DART AEROSPACE LTD	Work Order: 132347
Description: Crosstube Assembly, Mid Fwd	Part Number: D206-667-147
Inspection Dwg: D206-667-147 Rev: A	Page 1 of 2

DART AEROSPACE LTD HAWKESBURY, ONTARIO, CANADA	
DRAWING NO. D206-667-147	REV. A
TITLE CROSSTUBE ASS'Y (206L MID FWD)	SCALE NTS

DRAWING NO. D206-667-147	TITLE CROSSTUBE ASS'Y (206L MID FWD)	REV. A	DART AEROSPACE LTD ENGINEERING ORDER		D.E.O. NO. D206-667-147-A-1	SHEET NO. SHEET 1 OF 1	SCALE NTS
DRAWN 9	CHECKED ASS	MFG. APPR. [Signature]	APPROVED [Signature]		DE APPR. [Signature]		
DATE 11.07.15	DATE 11.07.20	DATE 11.07.21	DATE 11/07/21		DATE 11.07.21

DRAWING NO. D206-667-147	TITLE CROSSTUBE ASS'Y (206L MID FWD)	REV. A	DART AEROSPACE LTD ENGINEERING ORDER		D.E.O. NO. D206-667-147-A-2	SHEET NO. SHEET 1 OF 1	SCALE NTS
DRAWN AJS	CHECKED	MFG. APPR.	APPROVED	DE APPR.			
DATE 12.08.02	DATE 12.08.02	DATE 12.08.02	DATE 12.08.02	DATE 12.08.02

DETAIL P
BONDING STRAP INSTALLATION 2 PL

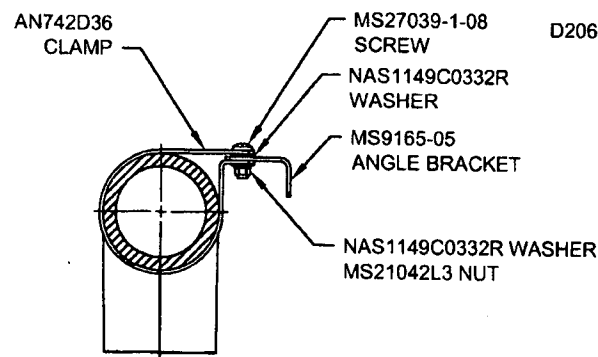
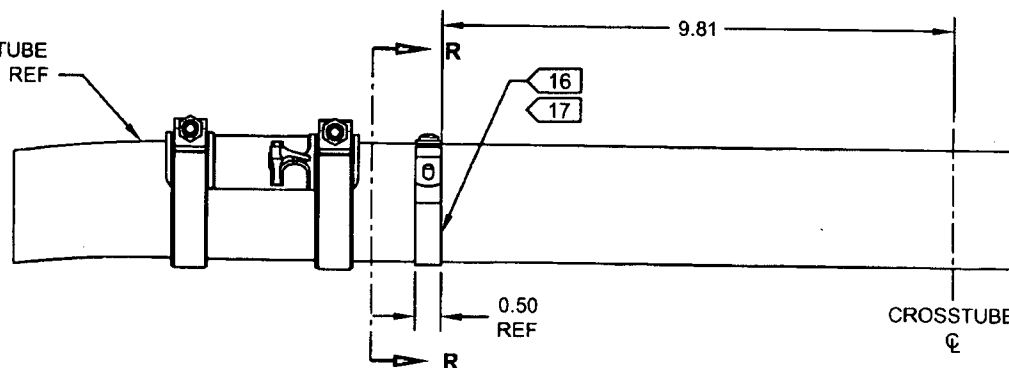
PURPOSE:

ADD ELECTRICAL GROUNDING STRAP

- 16) MASK AREA UNDER CLAMP PRIOR TO PAINTING
- 17) SEAL EDGES WHERE AN742D36 CLAMP MEETS WITH THE CROSSTUBE USING SIKAFLEX-241/-291 OR MIL-S-8802 CLASS B2 OR PROSEAL 890 SEALANT
- 18) PERFORM RESISTANCE CHECK TO ENSURE MAX RESISTANCE IS 10 MILLIOHMS

ITEM	QTY -147	PART NUMBER	DESCRIPTION
1	X	D206-667-147	CROSSTUBE ASSEMBLY (206L MID FWD)
10	2	AN742D36	CLAMP
11	2	MS9165-05	ANGLE BRACKET
12	2	MS21042L3	NUT (OR MS21042-3)
13	2	MS27039-1-08	SCREW
14	4	NAS1149C0332R	WASHER (OR AN960C10L)
